# Errata: CS5480 Rev B2 Silicon

(Reference CS5480 data sheet revision DS980F3 dated MAR'13)

Figure 1. Chip Select Pin  $\overline{\text{CS}}$  Model

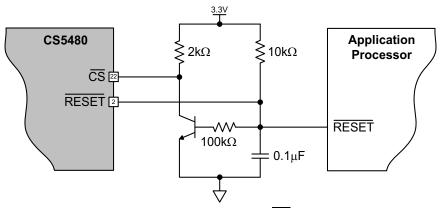
This erratum applies only to designs with chip select pin  $\overline{CS}$  tied low. If Serial Peripheral Interface (SPI) communication is interrupted, a synchronization error may occur on future SPI communications. A standard reset does not clear the SPI logic and correct this synchronization error.

Chip select pin  $\overline{CS}$  must be toggled to reset the SPI Interface. A NPN inverter may be added to the RESET signal to obtain a suitable  $\overline{CS}$  signal to reset the SPI Interface without the need for additional isolators. When the device is reset, using RESET, the serial peripheral interface is also reset.
